# TOWN OF EXETER, NEW HAMPSHIRE

## LEGAL NOTICE EXETER PLANNING BOARD AGENDA

The Exeter Planning Board will meet on Thursday, May 26, 2022 at 7:00 P.M. in the Nowak Room of the Exeter Town Office building located at 10 Front Street, Exeter, New Hampshire to consider the following:

The application of Willey Creek Co. for site plan review, lot line adjustment and Wetlands and Shoreland conditional use permits for the proposed relocation of Building D of the Ray Farm Condominium development and associated site improvements off of Ray Farmstead Road (Willey Creek Road). The subject properties are located in the C-3, Epping Road Highway Commercial zoning district and are identified as Tax Map Parcel #47-8-1 and #47-9. PB Case #22-3.

SHEET **C1.41**

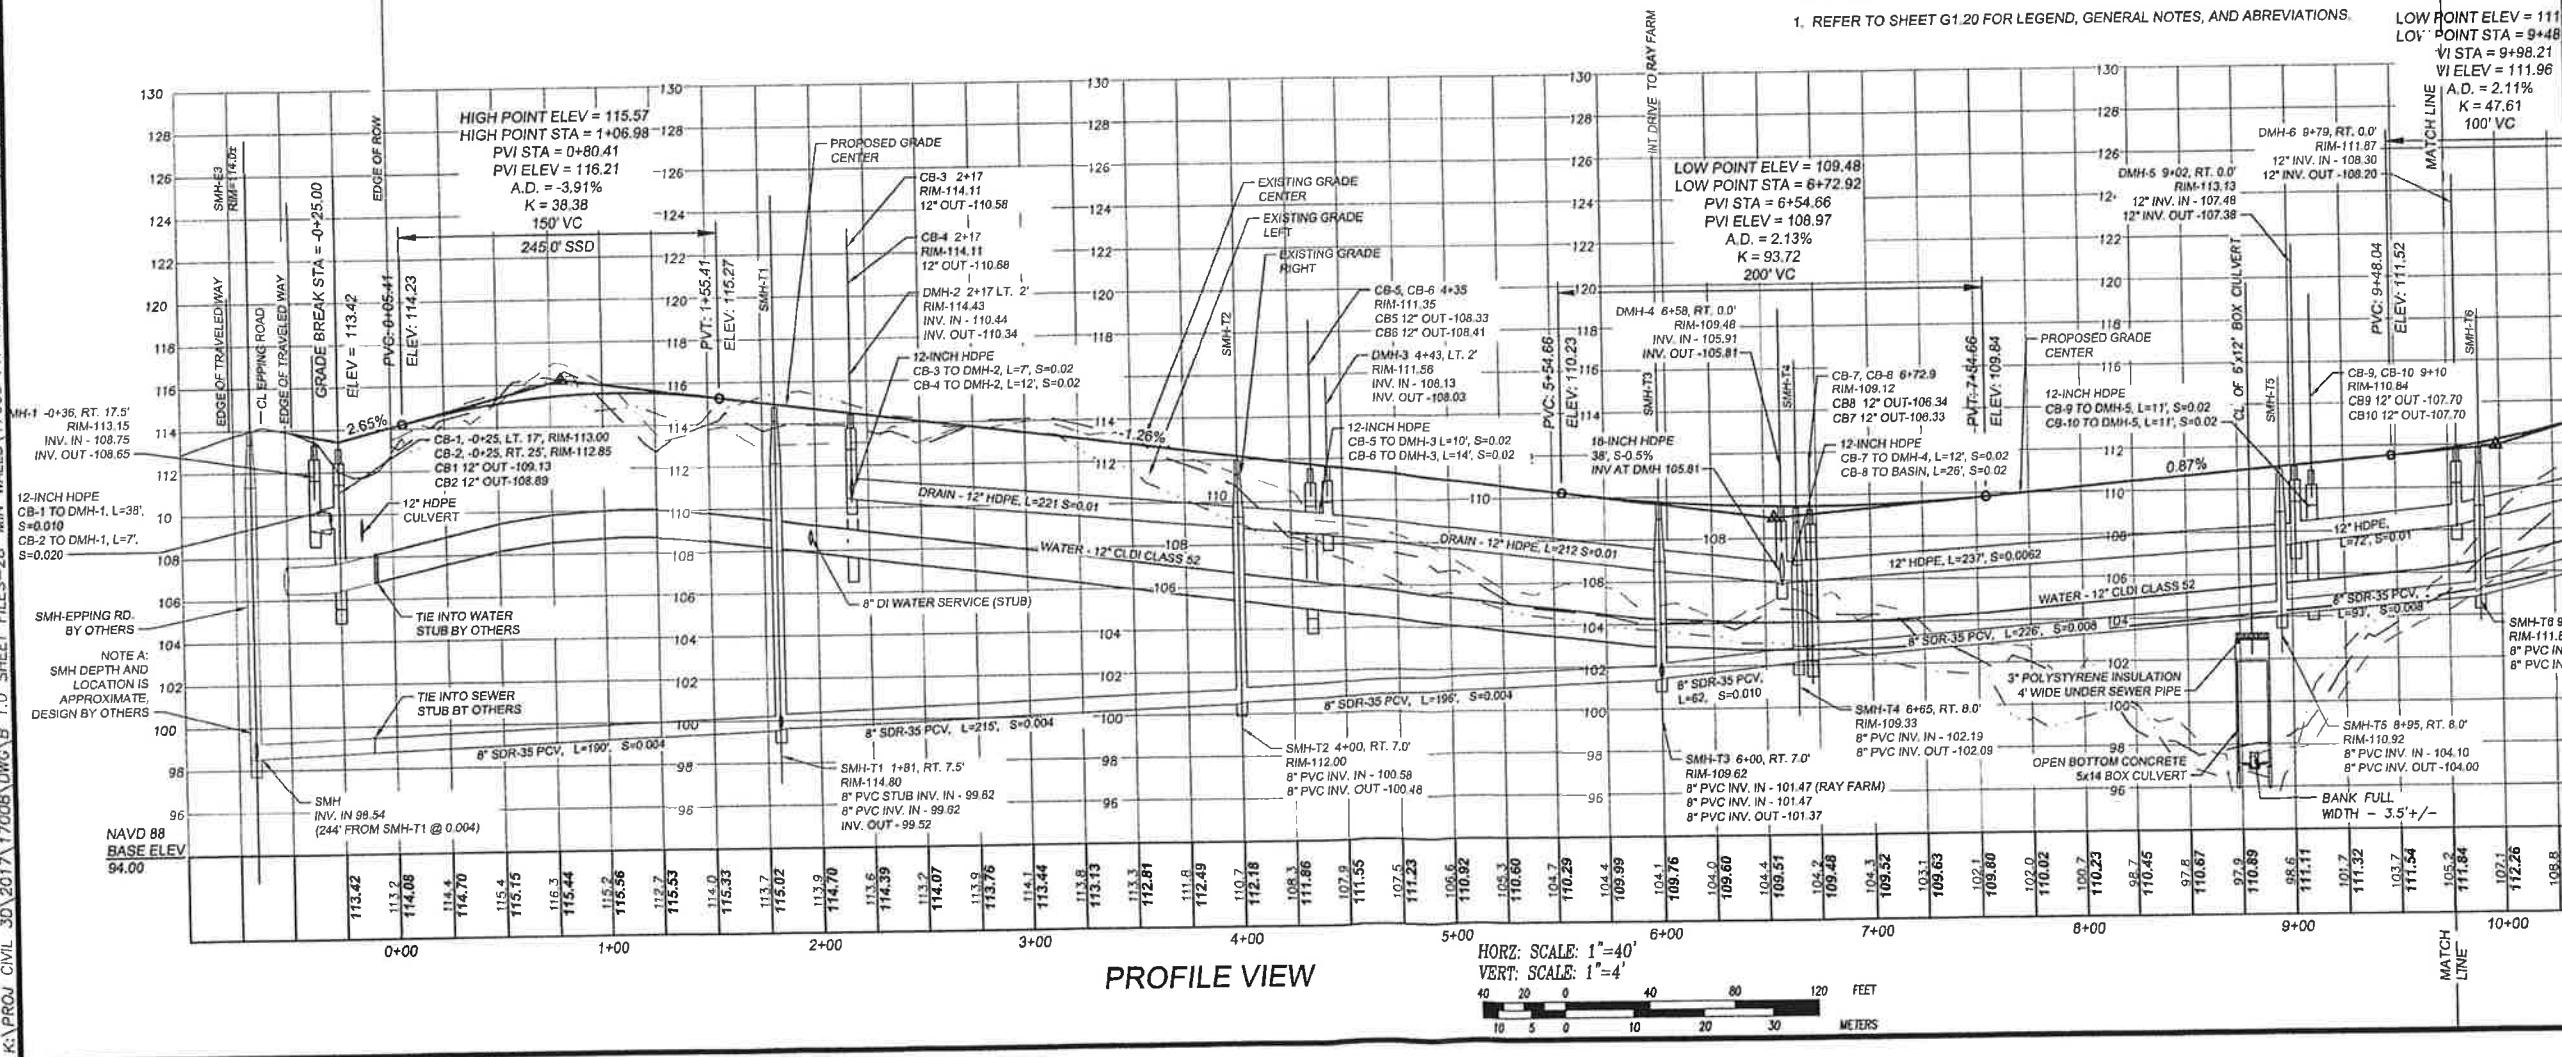
36. The existing edges of gravel and the existing and proposed tree lines should be shown along the construction access route.
37. Add the edge of ROW lines to the profile view on sheet C1.41.

37. Add the edge of ROW lines to the profile view on sheet Cl.41.
